HISTORIC AND DESIGN REVIEW COMMISSION

HDRC CASE NO: 2022-018
ADDRESS: 215 DAWSON ST
LEGAL DESCRIPTION: NCB 557 BLK 40 LOT W 27.96 FT OF S 97.4 FT OF 11
ZONING: D
CITY COUNCIL DIST.: 2
APPLICANT: Sarah Sauer
OWNER: Sarah Sauer
TYPE OF WORK: Construction of a 1-story commercial structure, fencing, site modifications
APPLICATION RECEIVED: January 02, 2022
60-DAY REVIEW: Not applicable due to City Council Emergency Orders
CASE MANAGER: Edward Hall

REQUEST:

The applicant is requesting a Certificate of Appropriateness for approval to construct a commercial structure on the vacant lot at 215 Dawson, located within the Downtown Design District. The proposed new construction will feature 1-story in height and a footprint of approximately 1,000 square feet.

1 SITE PLAN
SCALE: 3/16" = 1'-0"

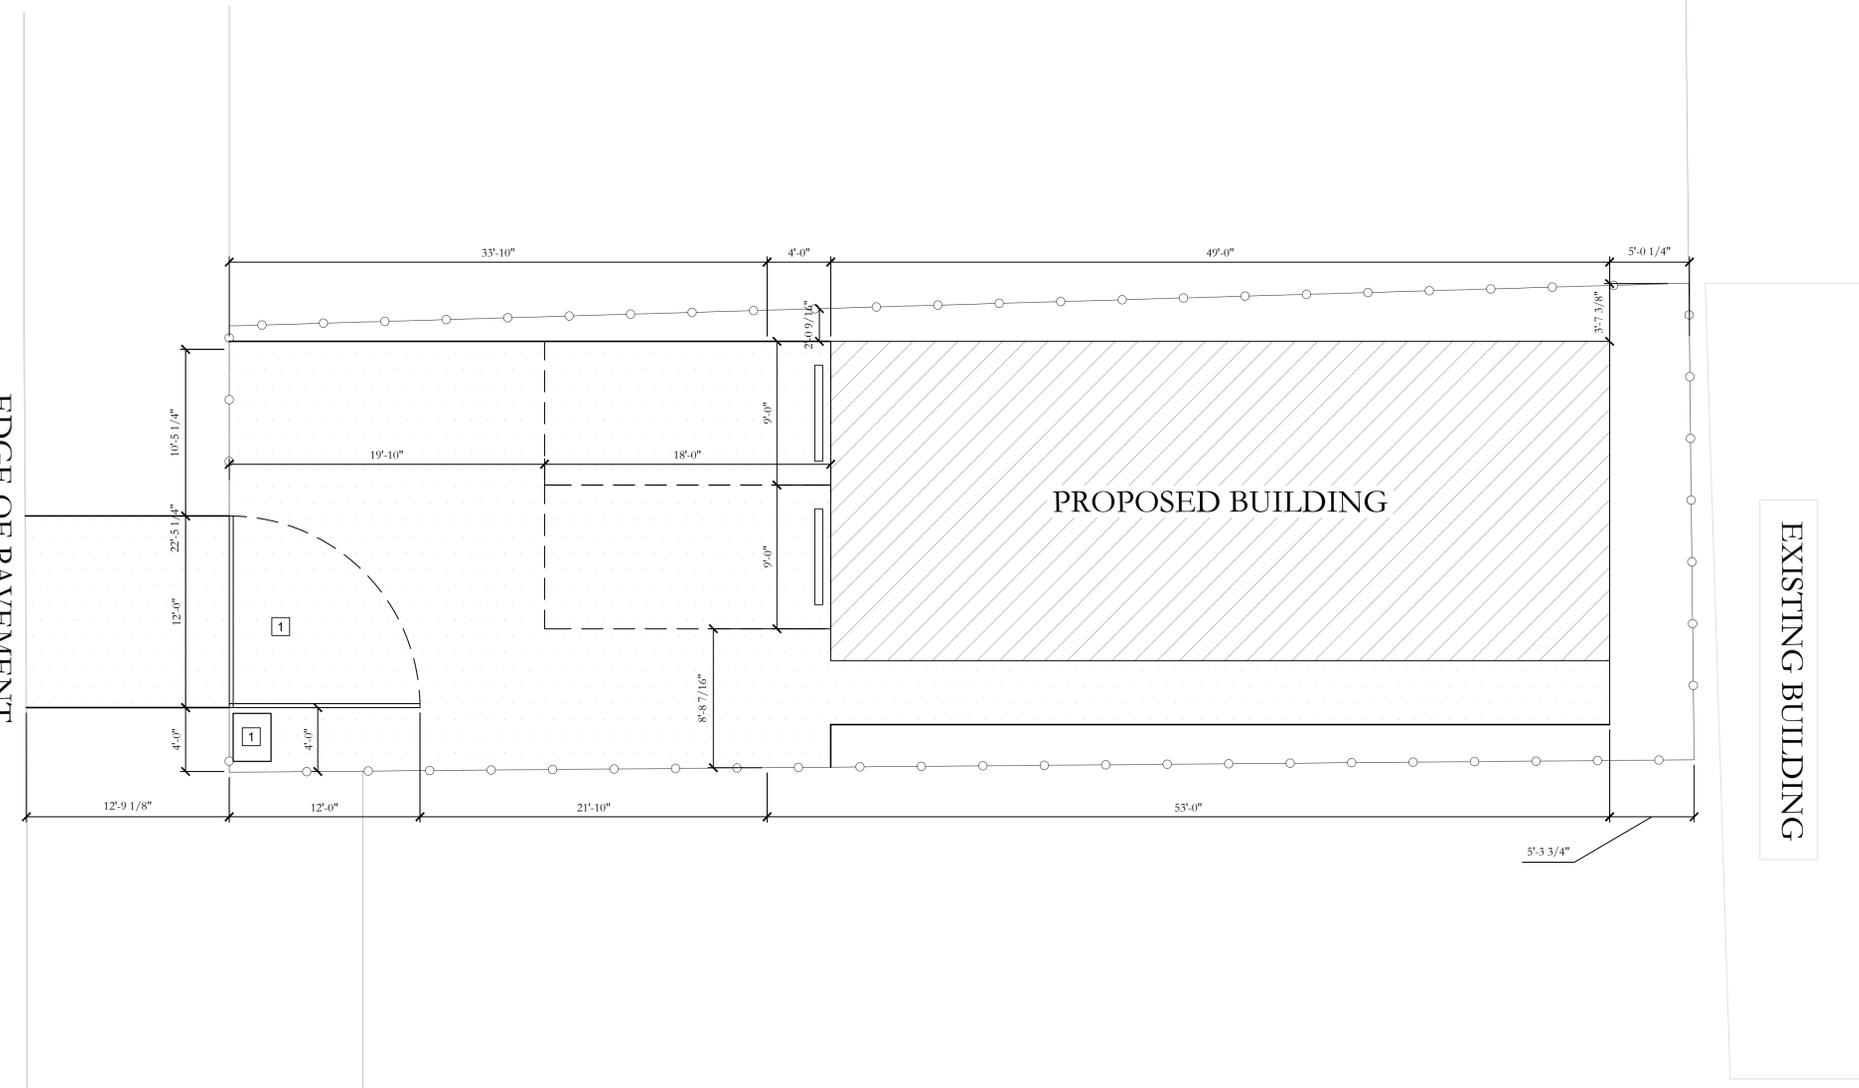
The Downtown Design Guide notes that a forty-eight (48) inch wide continuous pedestrian path of travel must be provided. Staff finds that that applicant is responsible for meeting all sidewalk requirements.

- c. LANDSCAPE & HARDSCAPE – The applicant has noted the installation of gravel throughout the lot. Generally, staff finds that additional landscaping elements should be incorporated into the design, such as native vegetation.

- d. PARKING & ACCESS – The Downtown Design Guide notes that parking should be located behind new construction. The applicant has proposed for parking to be located in front of the proposed new construction, between the new construction and the right of way. Staff finds the proposed parking location to be inconsistent with the Downtown Design Guide. Staff finds that the proposed parking should either be relocated to the rear of the structure, or that the proposed parking should be buffered by landscaping from view from the public right of way.

- i. That the proposed parking either be relocated to the rear of the structure, or that parking be screened and buffered from the public right of way with landscaping elements. A detailed landscaping plan should be submitted to OHP staff for review and approval to satisfy this stipulation.
- ii. That the applicant meet all sidewalk requirements.
- iii. That all mechanical and service equipment be screened from view from the public right of way, as noted in finding j.
